CITY OF HOBART

City Planning Committee Meeting

Monday, 15 February 2021

7.1 APPLICATIONS UNDER THE HOBART INTERIM PLANNING SCHEME 2015	7
7.1.1 35 Melville Street, Hobart - Partial Demolition, Alterations, Extension, Signage and Change of Use to Hotel Industry	7

FIGURE 3: Right hand vehicle parked approximately 1.2 meters outside the boundary.

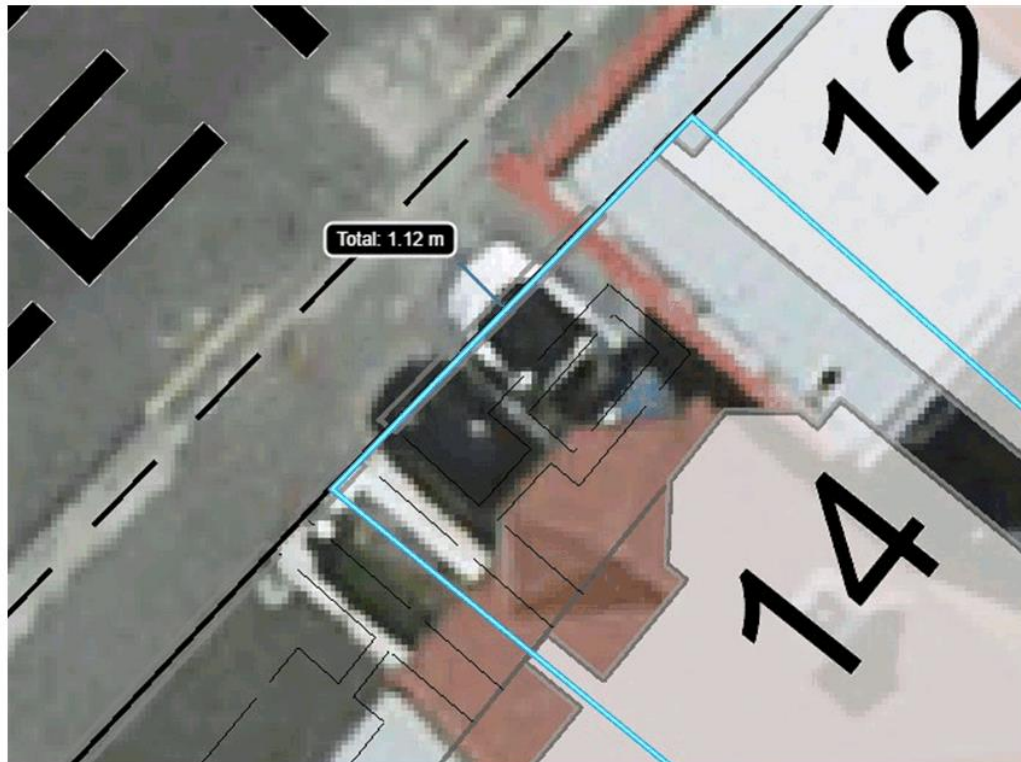
The two proposed parking spaces are 1.6 m shorter than the required minimum length and will clearly place any B85 vehicle outside the property boundary and into the road reservation (SEE FIGURE 1).

The car park plans provided 15/12/2021 show a width of 5.9 m wide x 3.8 m long. Minimum size requirements for a standard 90 degree parking space, user class 1 (general/all day parking) according to AS 2890.1 is 2.4 m wide x 5.4 m long (SEE FIGURE 2). Figure 3 shows an aerial view of the vehicles extending from the property boundary.
